REMARKS

DRAWING OBJECTION

FIG 8a

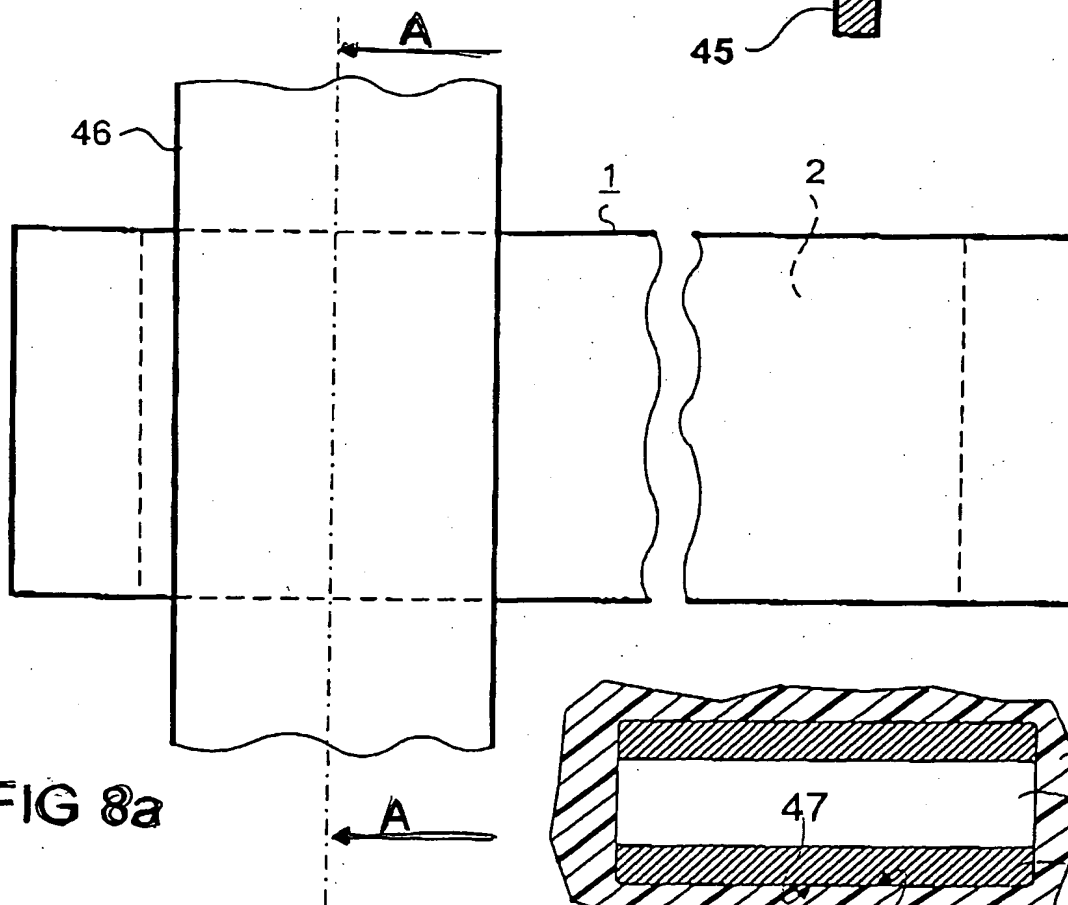
The Examiner has objected to the drawings, alleging that the drawings do not show every feature of the invention specified in the claims. Although Applicants do not necessarily agree, and although much of the objected language has been removed from the claims, Applicants submit drawing changes in a Drawing Correction Approval Request. In the Drawing Correction Approval Request, Applicants hereby submit corrections to Fig. 8, wherein Fig. 8 has been relabeled as Fig. 8a, with cross-section indicators "A" being added; and wherein new Fig. 8b has been added, illustrating the cross section A-A of Fig. 8a. Approval of these drawing changes is respectfully requested.

As approval of this drawing change is anticipated, Applicants further submit a Letter to the Official Draftsperson, including a new drawing sheet which includes formal drawings of old Figures 6 and 7 and new Figs. 8a and 8b. Entry of this new drawing sheet, replacing the previous sheet including Figs. 6, 7 and 8, is respectfully requested.
